CHANGE ORDER NUMBER: 2HNTB Corporation
Round Rock1. CONTRACTOR: QA Construction Services Inc.Project: Great Oaks WLRelocation2. Change Order Work Limits: Sta. 502+25 to Sta. 512+27

CHANGE ORDER NUMBER: 2

Project # Great Oaks WL Relocation-3185

Change Order No. 2

REV. NO.	REVISION DESCRIPTION	(C)ORRECT, (A)DD, (V)OID SHEET NUMBERS	APPR'D BY:	DATE
1	ADJUSTED SHEETS	(C) C-201, C-202, C-203, C-204, C-205	SF	2/07/2020
2	ADDED DETAILS	(A) C-504	SF	2/07/2020

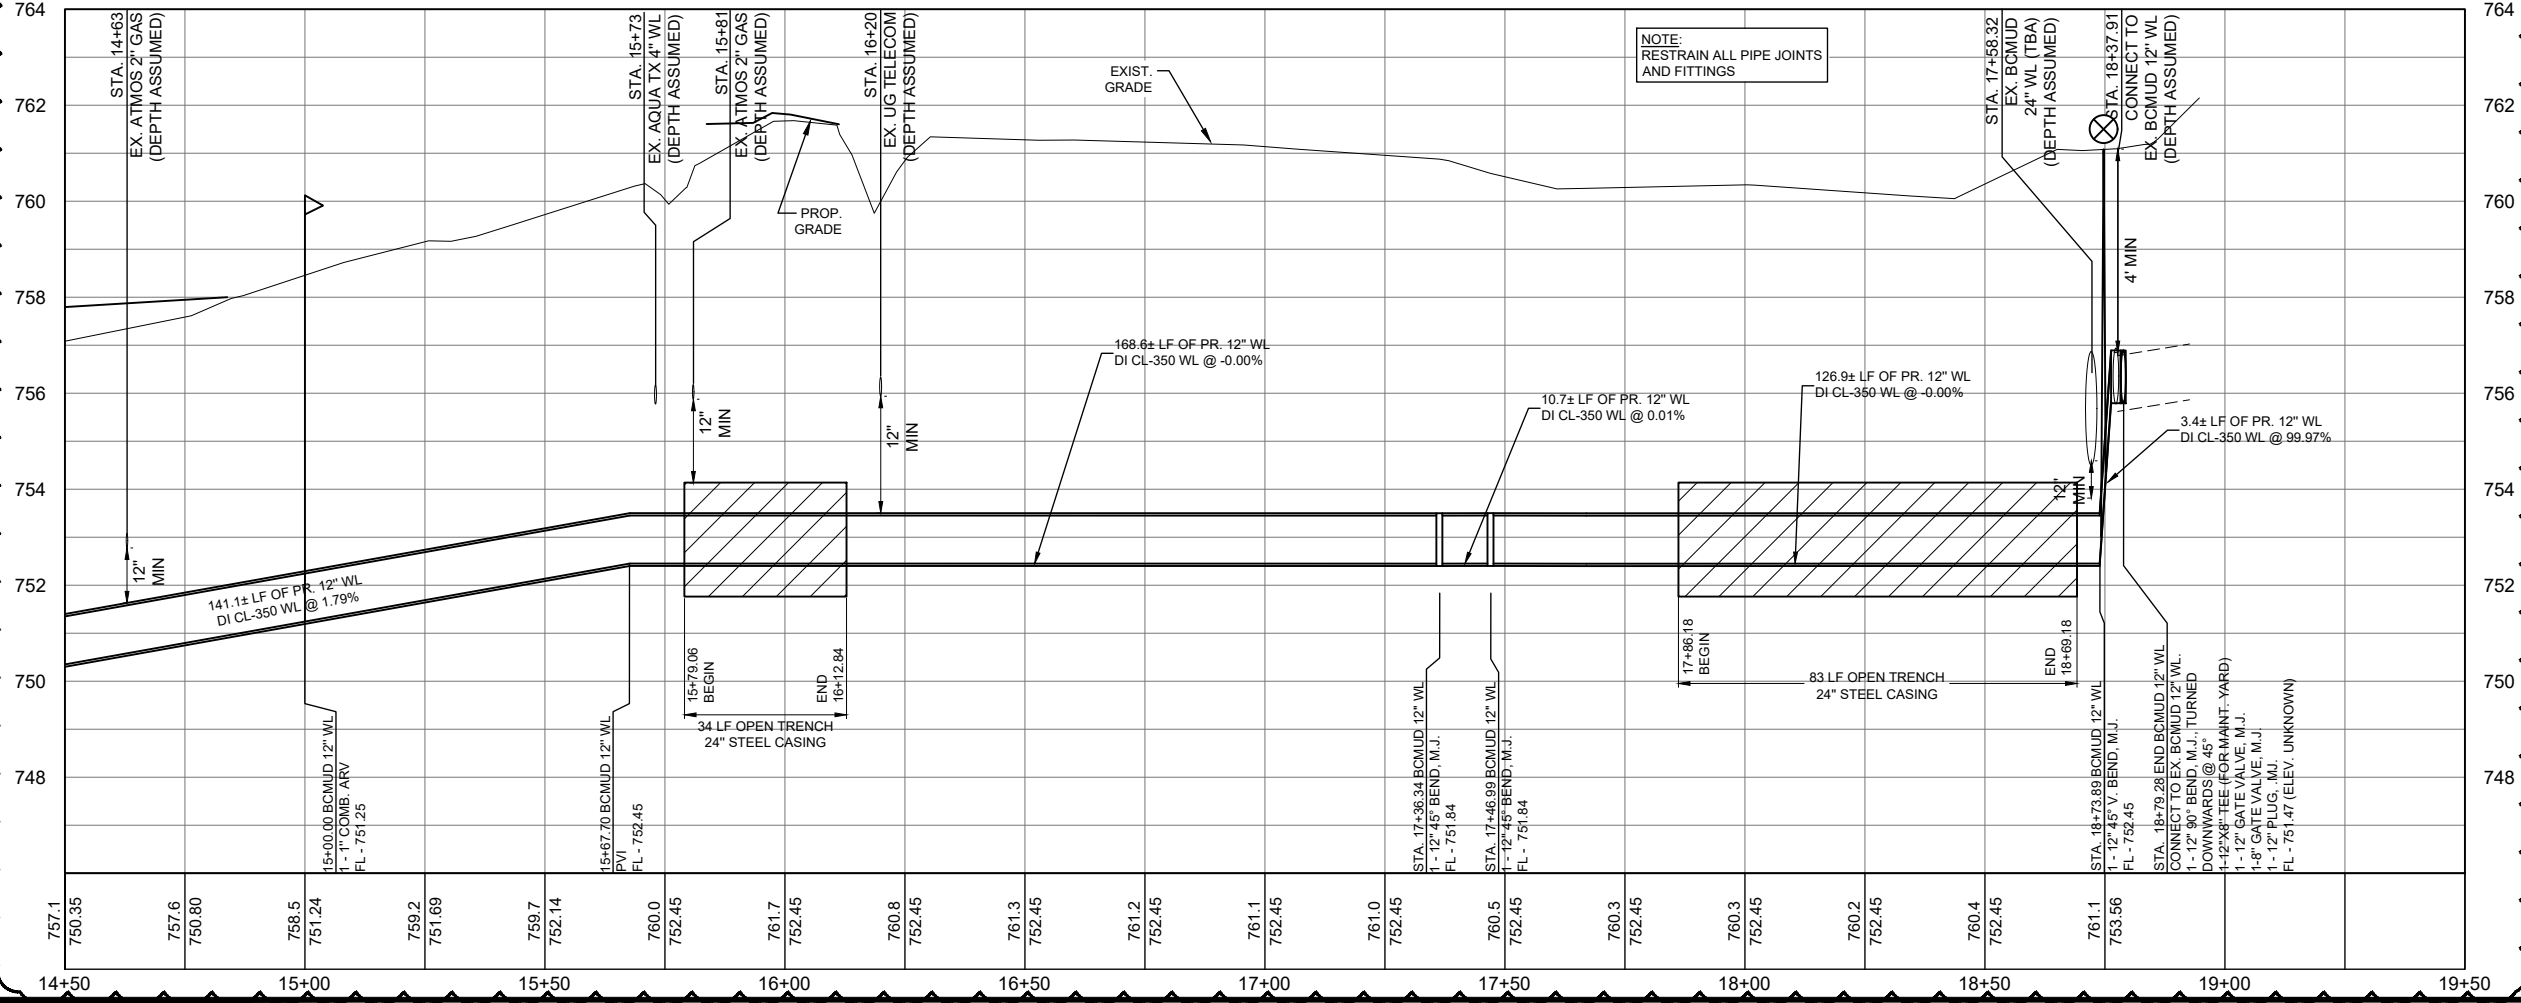
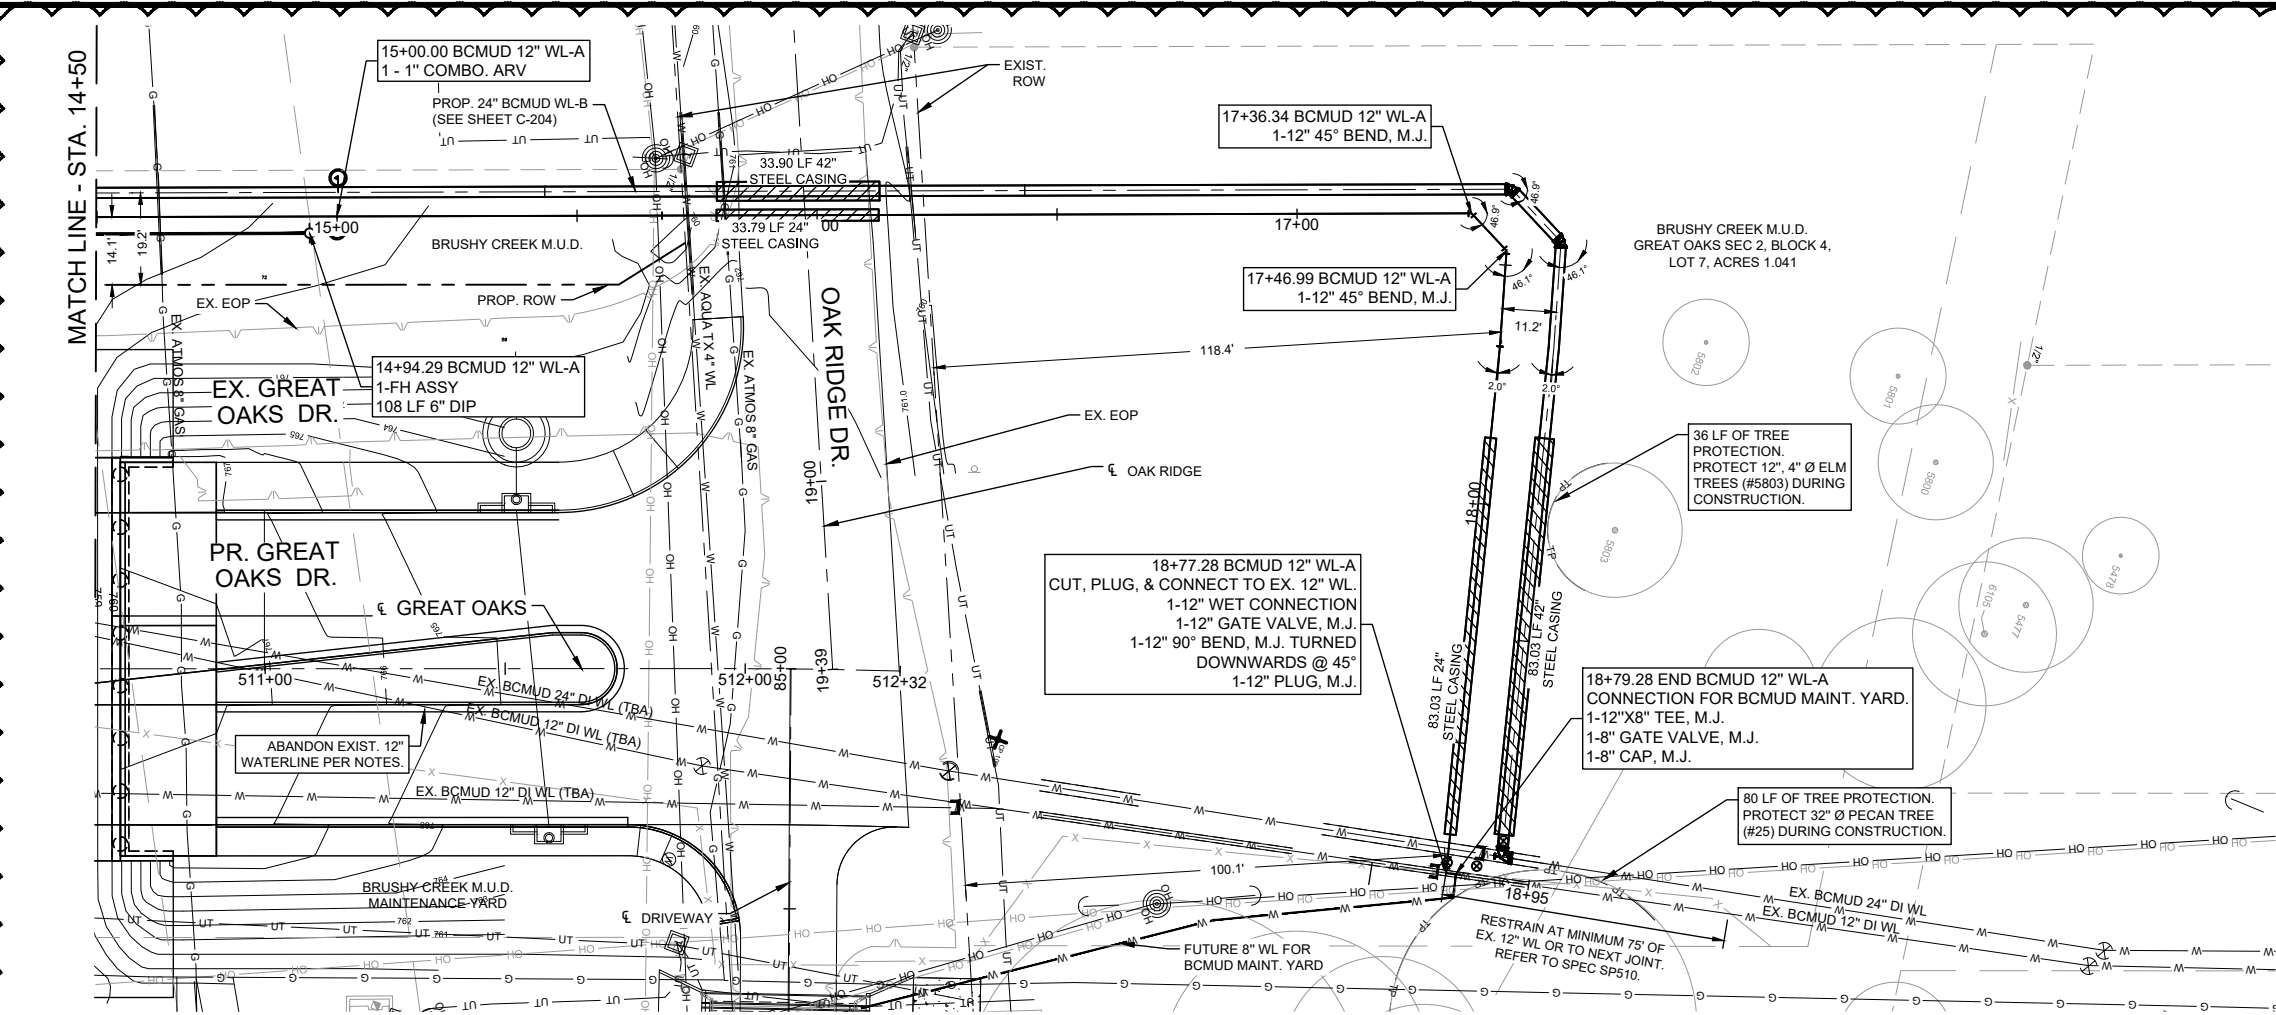
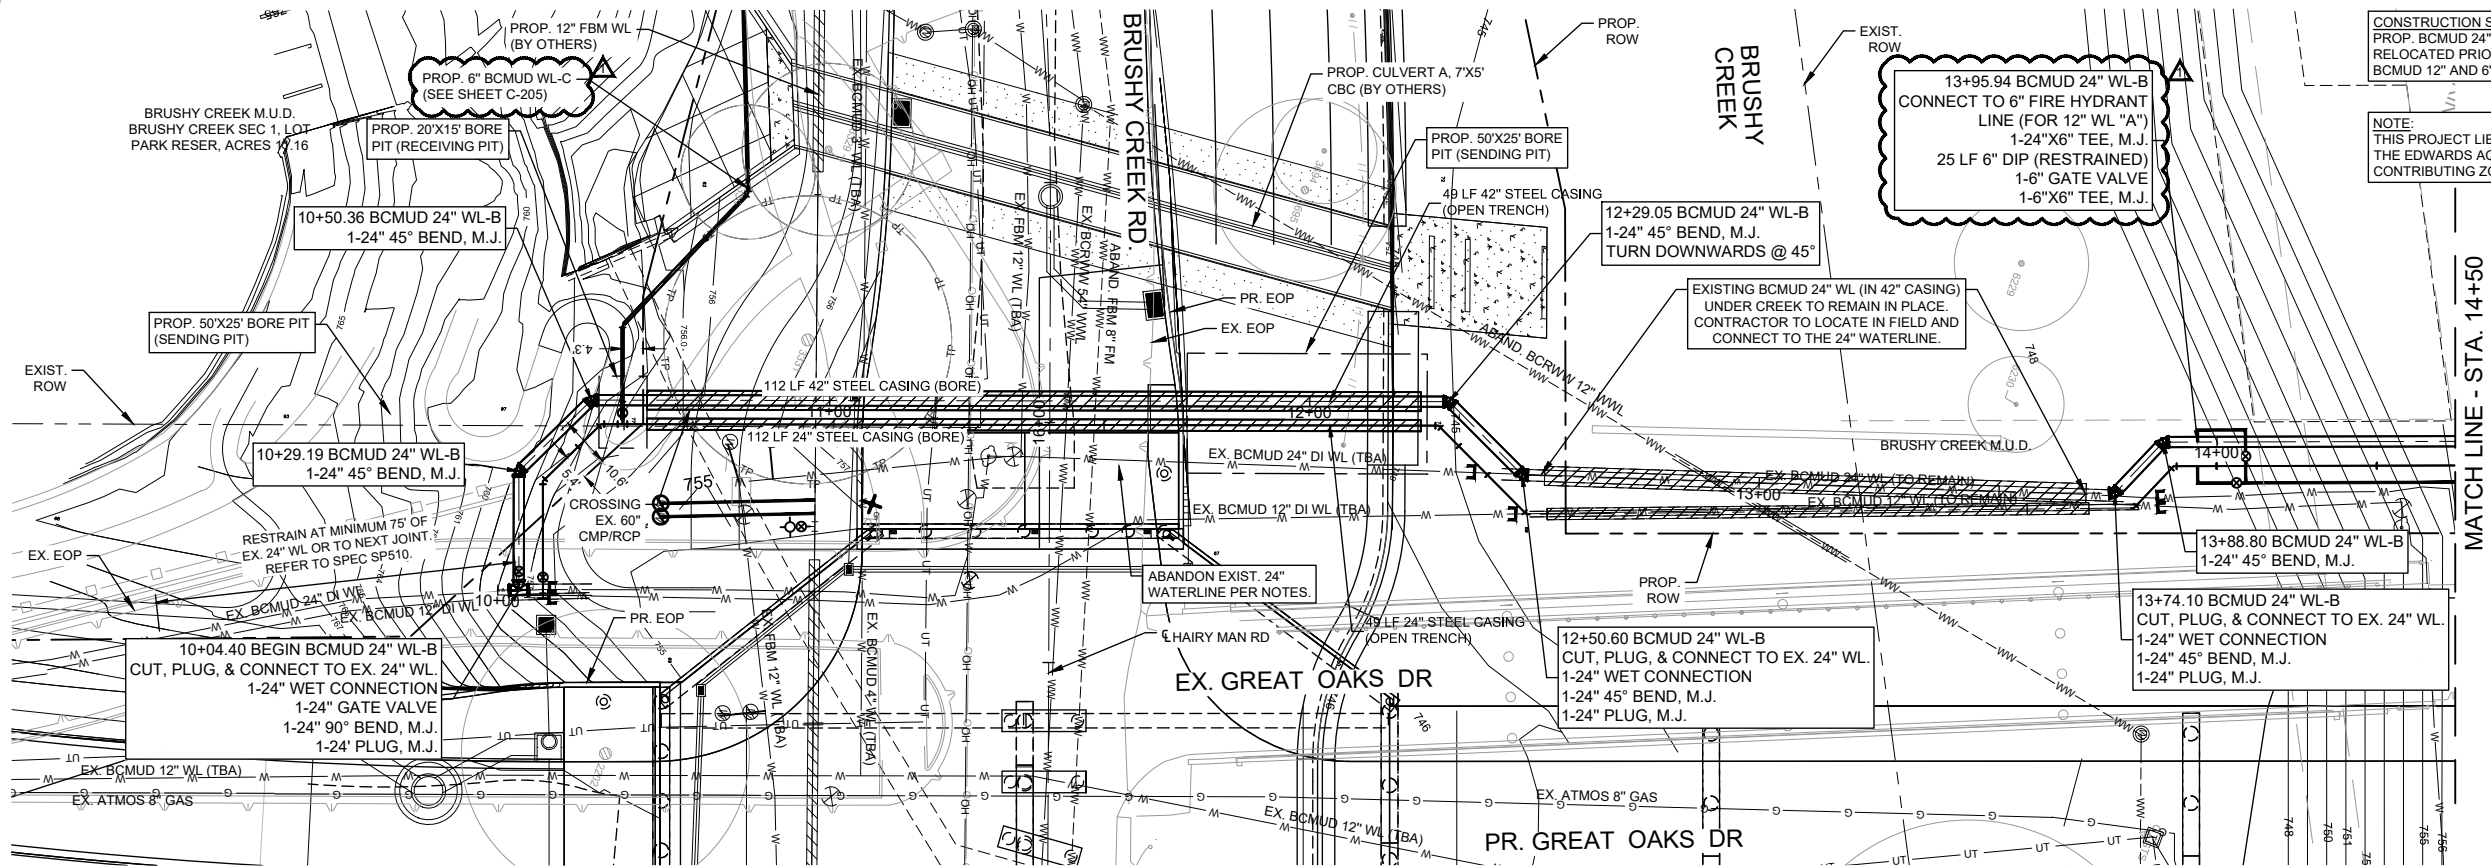
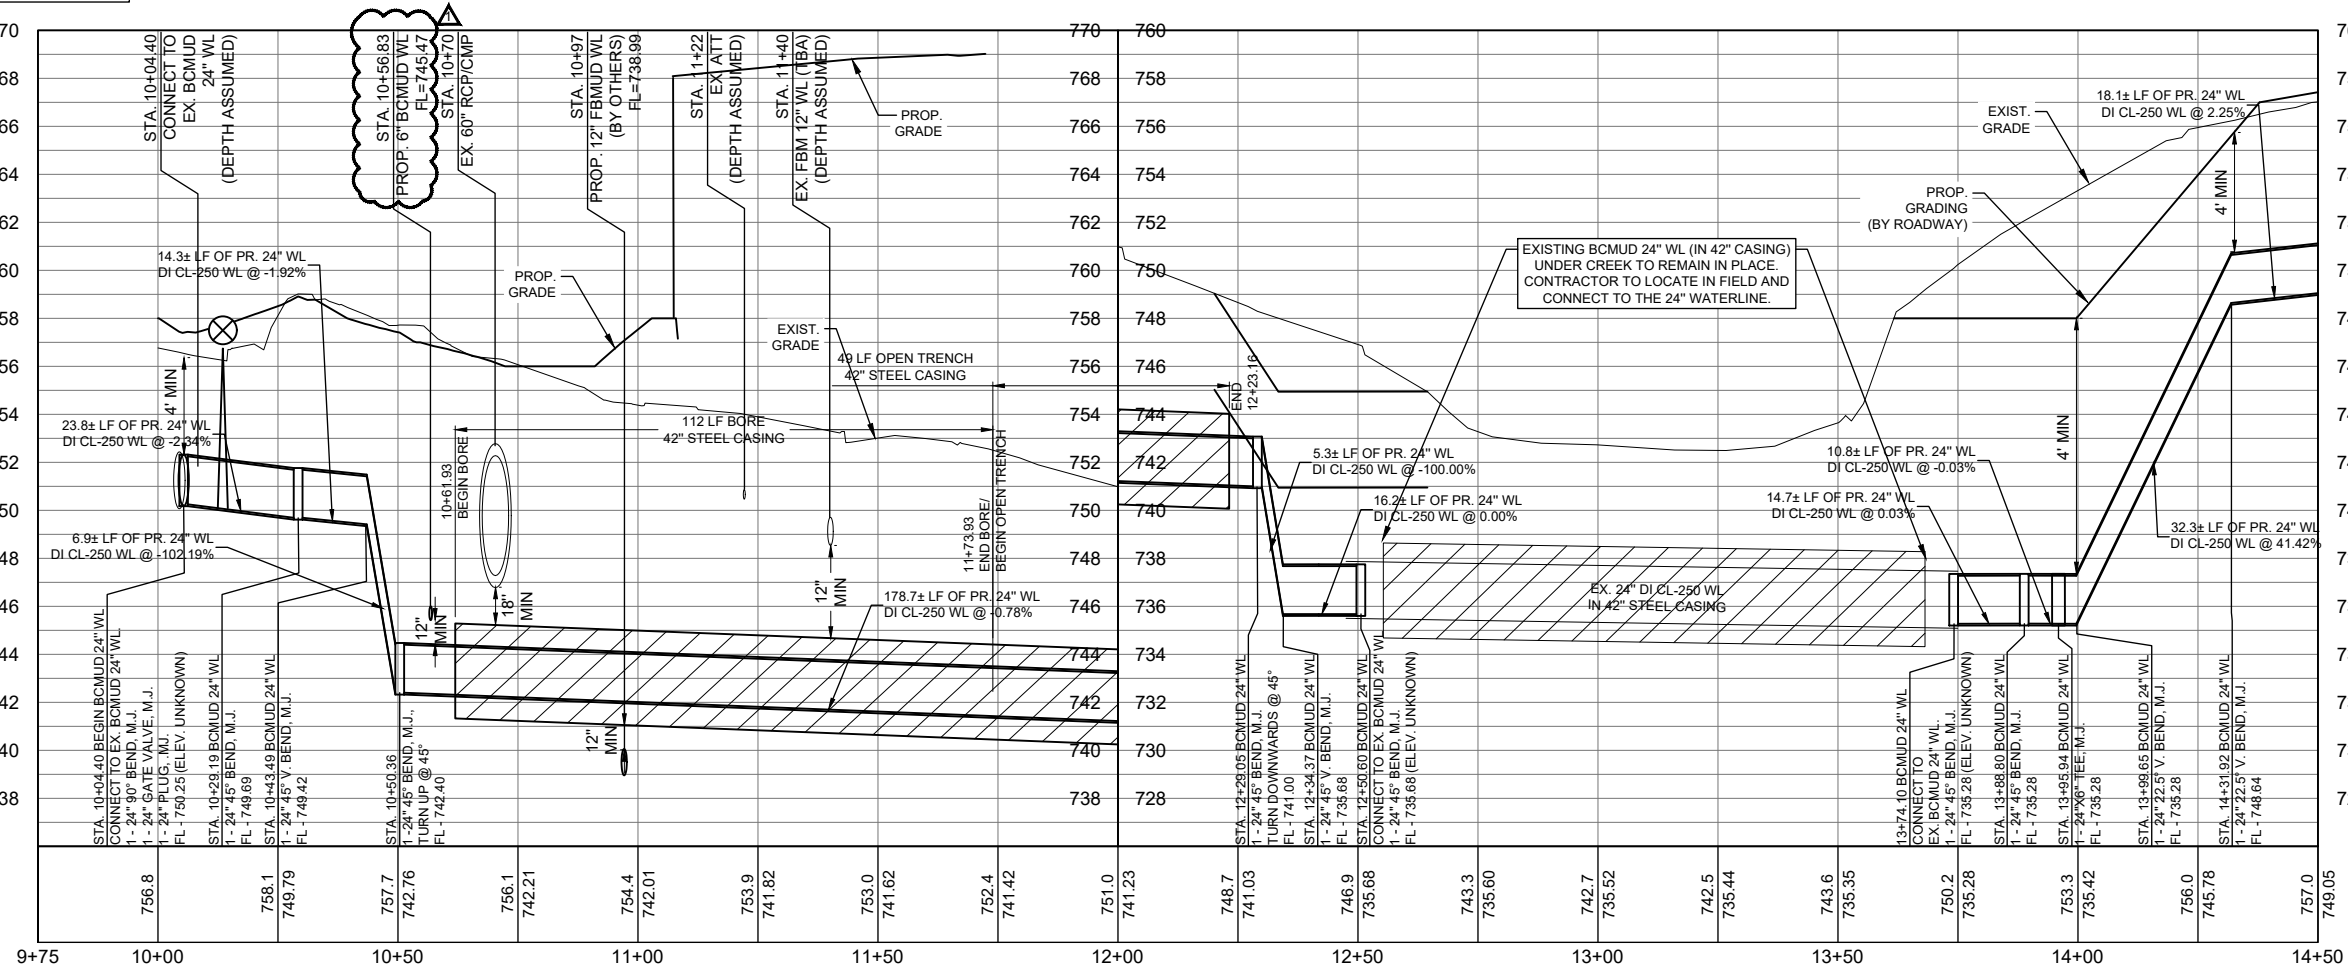
This Change Order adds revisions to the Brushy Creek MUD water line design that did not make it into the original plans. These revisions include changes requested by the Brushy Creek MUD (BCMUD) to the water line alignment for the 12" and 24" pipe north of Oakridge Drive. The BCMUD also requested to change the size of Water Line C from 4" to a 6" water line, add pipe restraint on the existing 3" water line and the addition of a 6" Pressure Release Valve Assembly (PRV). These changes are necessary, because the specification for minimum size water line is 6 inches.
